AGENDA

Architectural Review Board

October 25, 2016
Council Auditorium, City Hall
103 North Perry Street

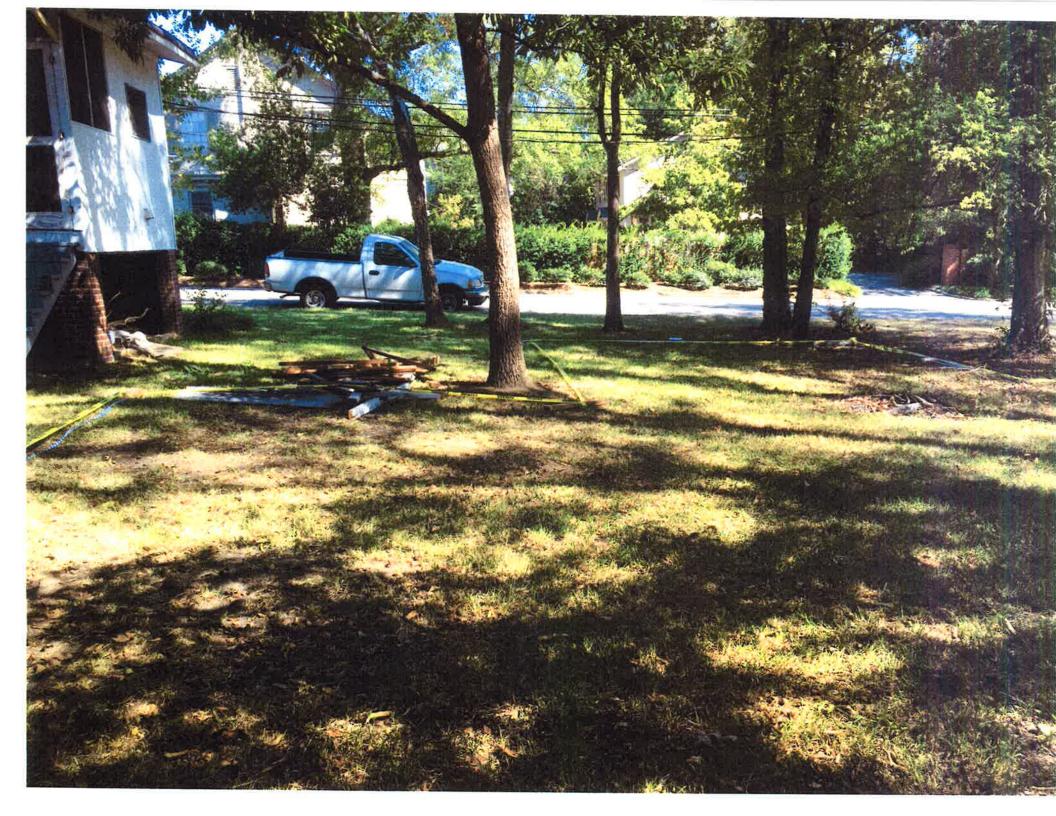
REMARKS: The petitioner is requesting permission to install a 6 car parking area behind a duplex that will be accessed from a service alley on Ridge Avenue. The proposed surface material is crushed run contained by railroad ties, and irregularly shaped, working around existing trees. If screening is required, a wax leaf viburnum is proposed to be installed to meet Landscape Ordinance guidelines to create a screen, spaced 24"-36" on center.

- Screening has been required for front yard parking areas to minimize the visual impact of cars from the street. As this property is on a corner lot, and the requested parking will take up a sizeable area in the rear yard, staff recommends screening on the Ridge Avenue side of the parking area to minimize that visual impact from the street.
- No comment received from Urban Forester regarding issues related to the parking area being worked around existing, mature trees.

FAMILY PORCH ELEVATION

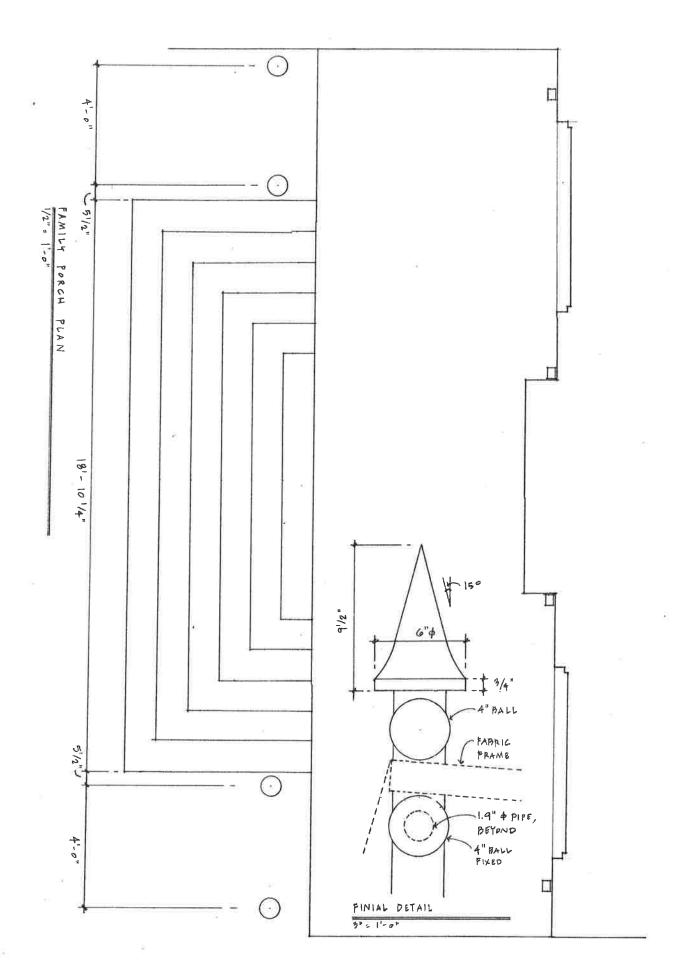
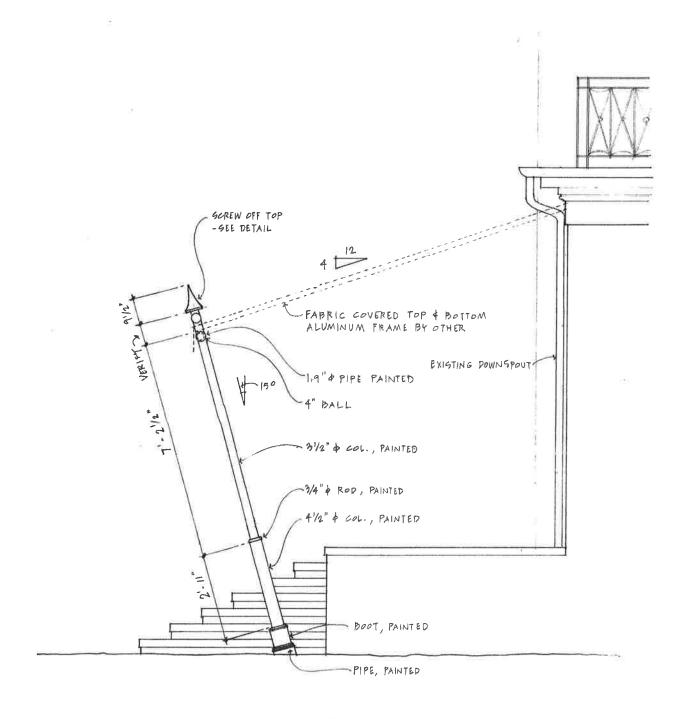
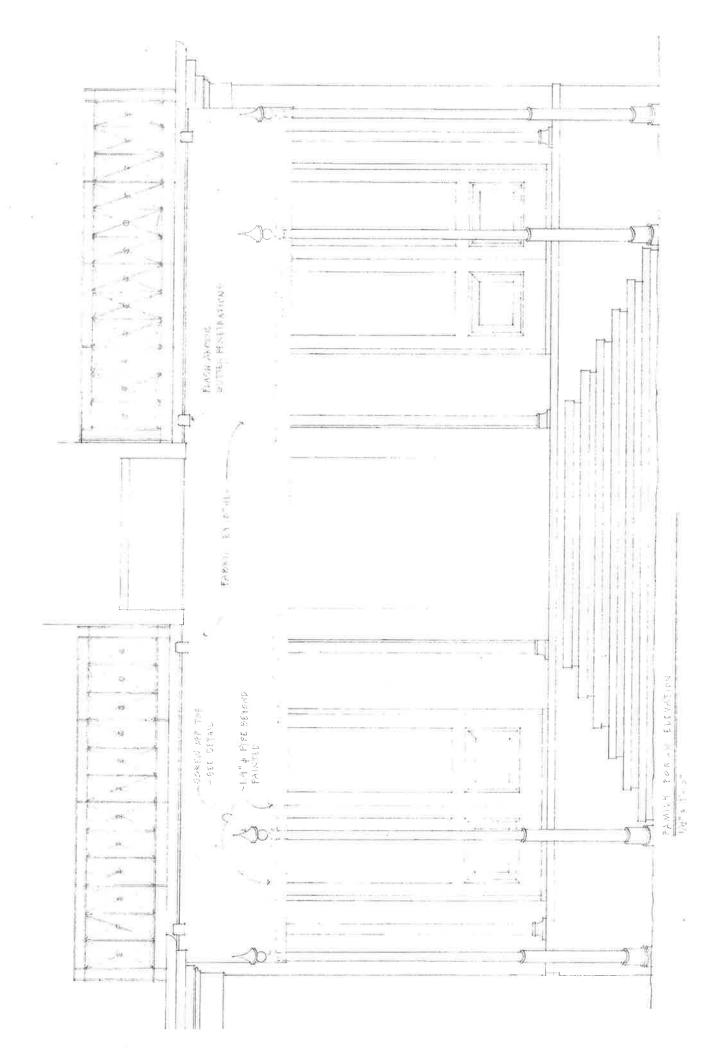
REMARKS: The petitioner is requesting approval to install a fabric awning over a porch on the north elevation (Rose Lane side) of the house. The awning will be a monochromatic fabric in a shade similar to the house color on an aluminum frame and supported by 4 decorative posts as illustrated and set in an engineer designed footing.

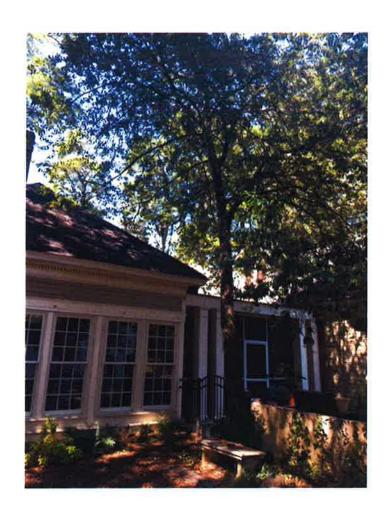
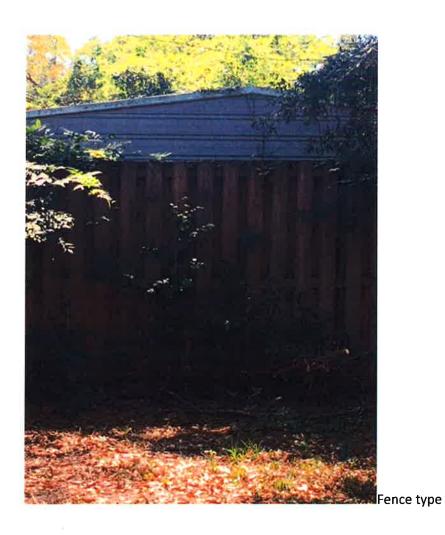
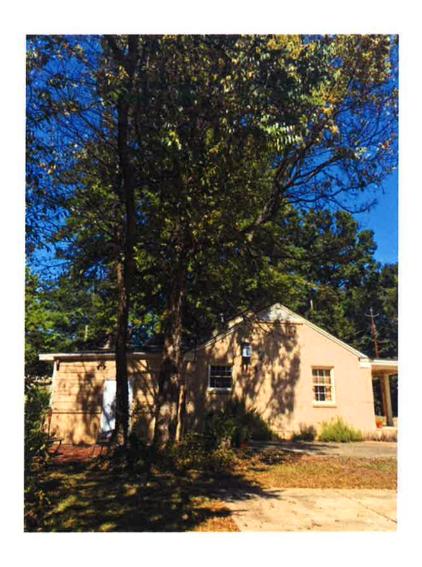
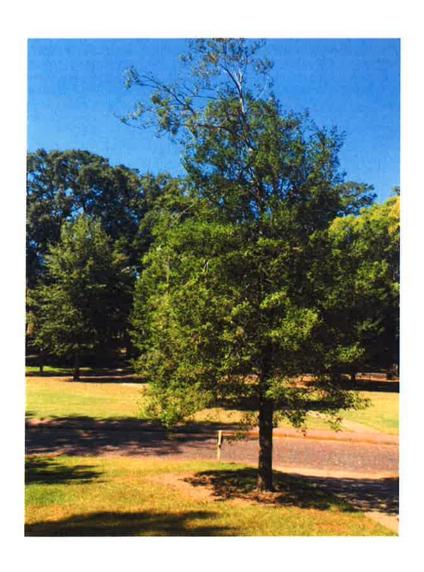
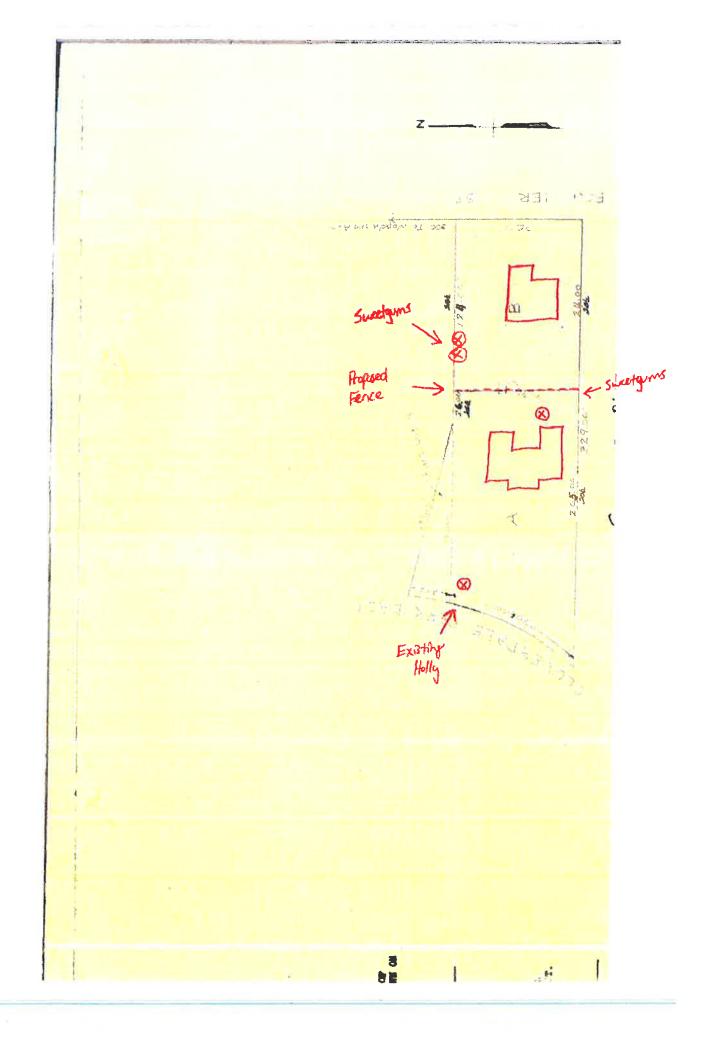
REMARKS: The petitioner is requesting permission to build a shadowbox fence along the rear property line to separate the yards between 2444 Boultier and 2425 East Cloverdale Park. The petitioner would also like to remove a large holly (now tree sized) in the front yard of 2425 East Cloverdale Park, one sweet gum in the rear yard near the proposed fence location, and 2 sweet gums on the north property line of 2444 Boultier. The proposed replacements are minimum 2" caliper, to be installed near the location of the removed trees, and the proposed species are 2 oaks, one maple, and one dogwood to be planted in November, 2016.

- Shadow box fences have been approved in rear yards.
- No comment received from Urban Forester regarding tree removals.

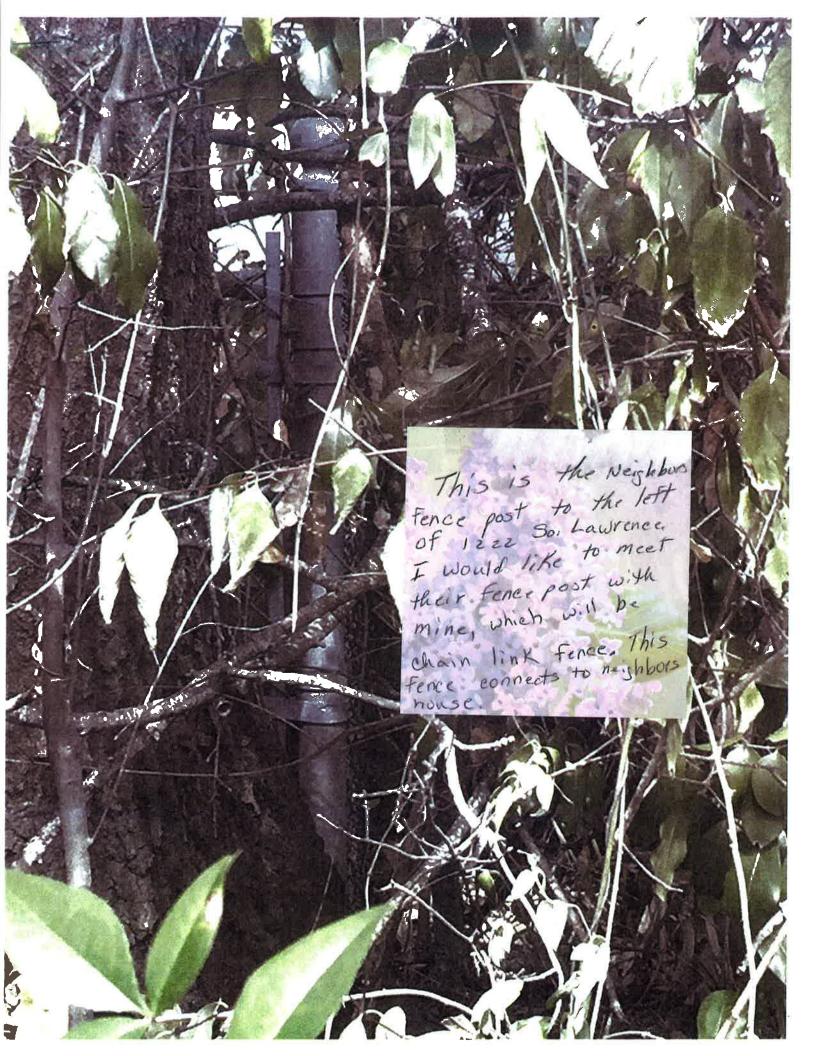
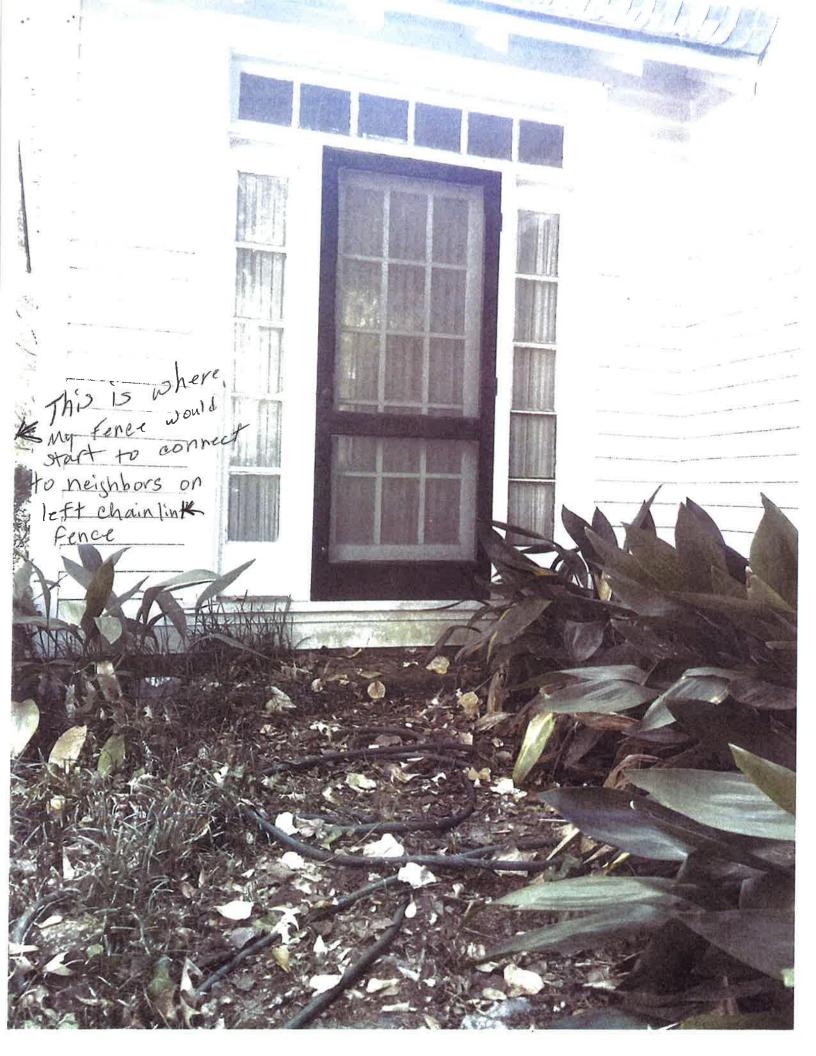
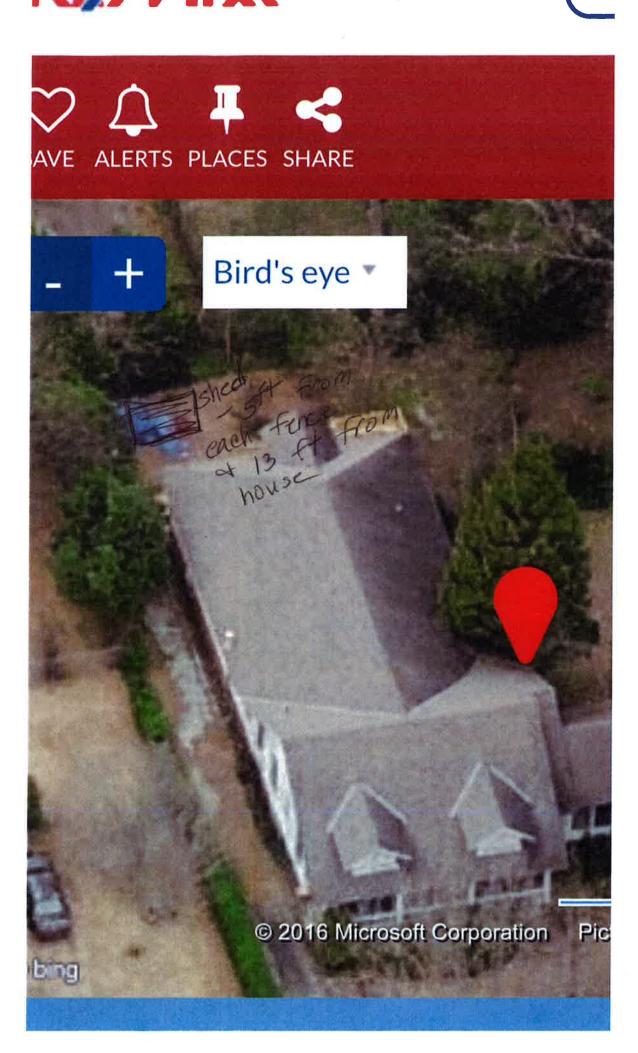
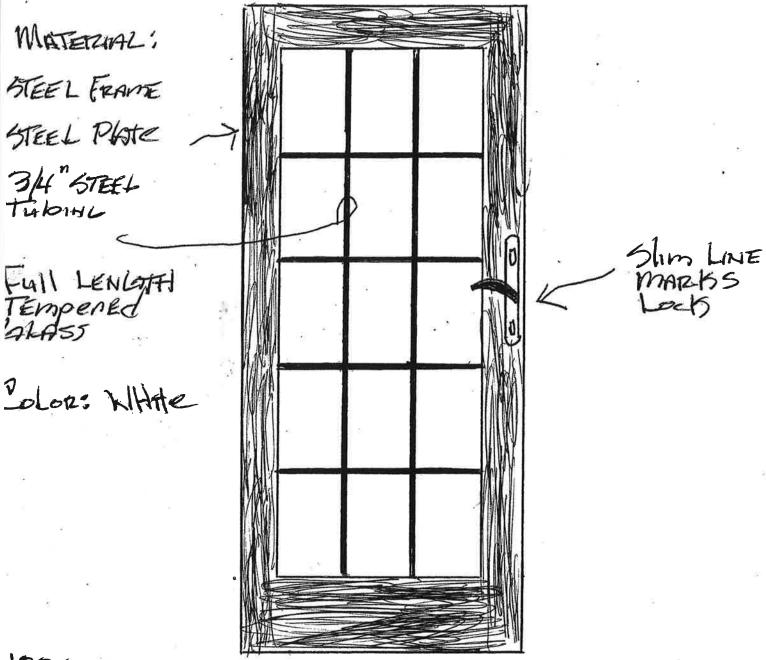
- A 4' tall chain link fence running from both property lines to the house where illustrated to enclose the rear yard. The fence material matches the existing fences on the property lines. Each side will have a matching gate.
- An 8'x10' storage building at the rear left corner of the yard, 5' off the property lines. The shed will have an overhanging eave, sided with horizontal wood lap siding, shingles to match the house, with solid double front doors (6' opening). The building will be painted white to match the house, and set on block piers that will also be painted.
- Security doors for front door and sunroom (faces rear of property). The door will be a steel frame with a steel plate and 3/4" steel tubing to duplicate the lite configuration of both doors as illustrated. The door will be white.

- While the Board sometimes balks at requests to use chain link fence, it is a historic fence material that was used primarily in rear yards, and sometimes along property lines to the street (not a front yard enclosure). The petitioner wishes to match the existing fence on the property line to enclose the rear yard, and the location of the proposed fence is set back far enough that it will not have a great visual impact from the street.
- The Board may wish to request the type of door for the storage building be specified.

MODIFICATIONS TO 17 MILDRED ST. MORE THAN ... PUT YOURSELF IN THEIR SHOES

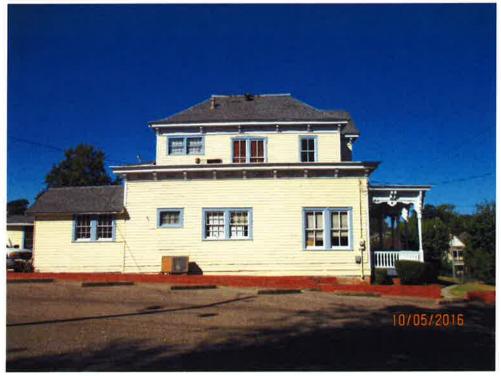
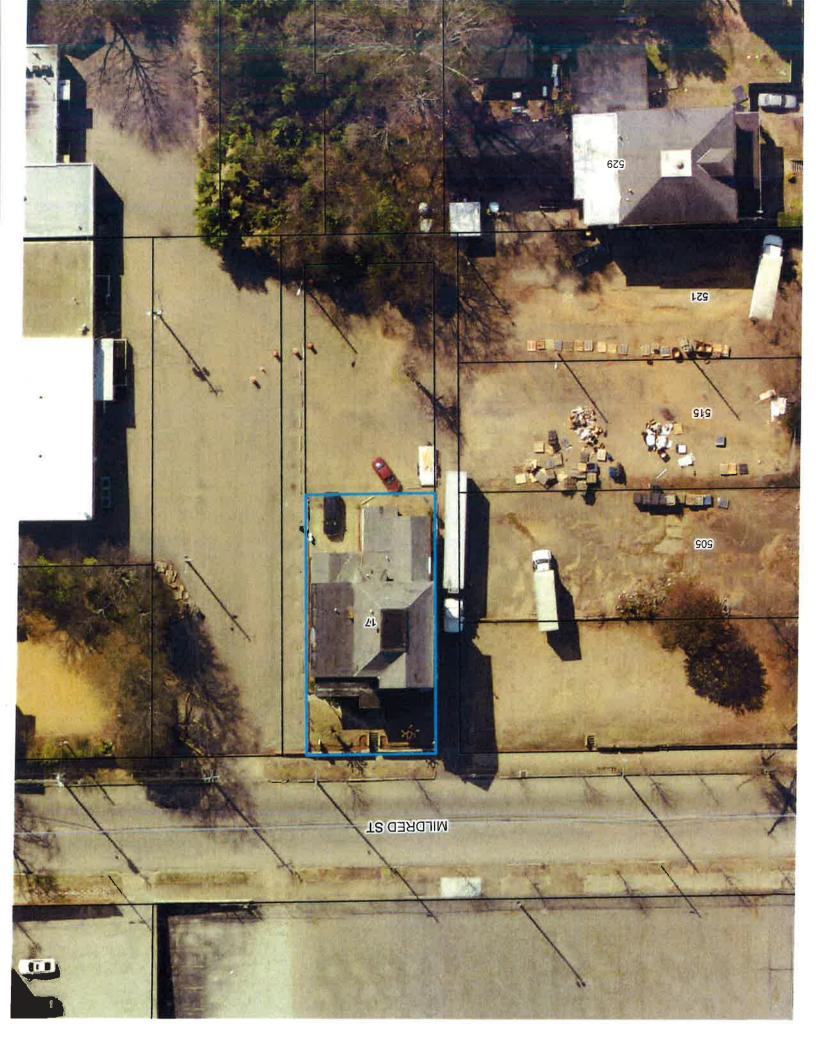
REMARKS: The petitioner is requesting permission to remove several rear additions that were added to the main house block over time, and replace those with one single story addition to serve as a new meeting room/gallery space. The addition would be a glass enclosure with bronze aluminum framing with exposed steel in a bronze color on the columns and frieze as illustrated, and have a standing seam metal roof.

A new sign would be installed in the location of an old sign at the corner of Mildred and Sayre Street as illustrated. (size not specified, 20 SF of sign face is recommended maximum. T4O has a maximum of 15SF, but as a blade sign—which is not practical for a structure originally constructed for residential use).

The request also includes new paving, for brick walkways where illustrated, and a new parking area of exposed aggregate concrete where illustrated. No screening is proposed at present but would be required.

- Sign size needs to be specified.
- Screening needs to be proposed for the parking area. Parking on a lot separate from the building will also require a variance from the Board of Adjustment for permission to use that space for parking. Any approval from the ARB on design does not imply that the use is permitted.
- The lot was split in half by deed and not platted, a replat of the lot will be required before the addition can be constructed. A coverage variance is also likely to be required from the Board of Adjustment.
- Plans are oversized and copied separately from agenda.

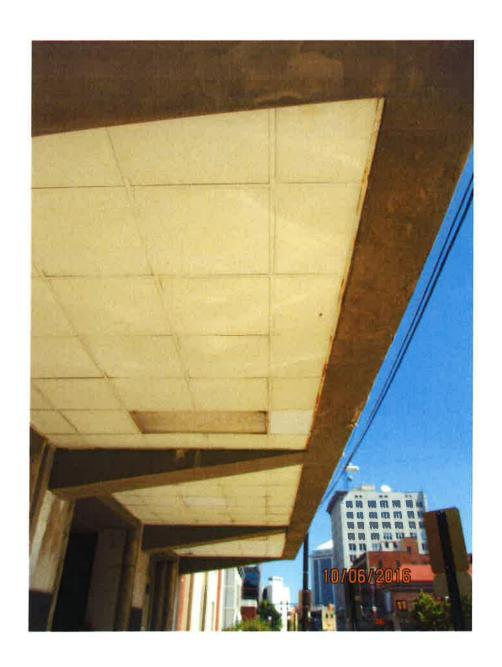
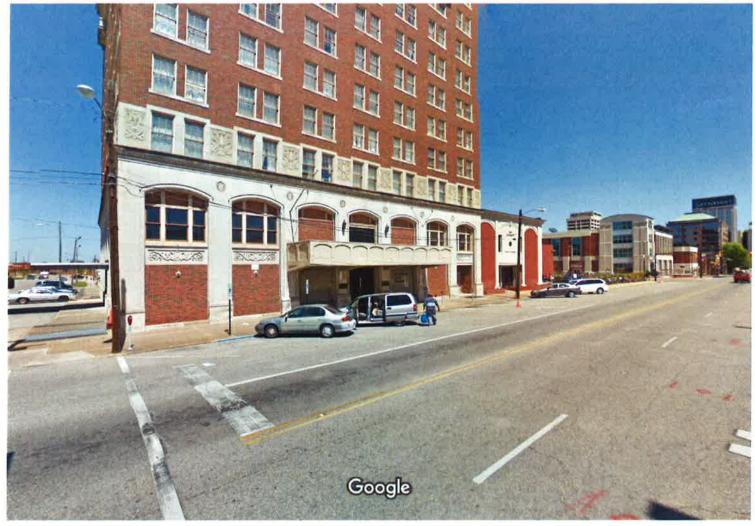
REMARKS: The petitioner is requesting permission (after the fact) to remove a once story drive through porte cochere on the Catoma Street elevation and one story rear addition that accommodated a bank drive through window (see Google Street view images).

The proposal includes replacing the existing front canopy under panel/soffit (squares within a suspended grid frame) with a vinyl beadboard soffit.

- Vinyl is generally a four letter word with regards to its application to historic structures. There are other, alternate materials that may be more appropriate under the awning that would also be durable and have longevity. An image of a metal bead board installed under a canopy on South Perry Street is attached. The other two canopies in that block have used wood bead board plywood.
- A full sized set of plans will be available in our office prior to the meeting and at the meeting.
- Plans are oversized and copied separately from agenda.
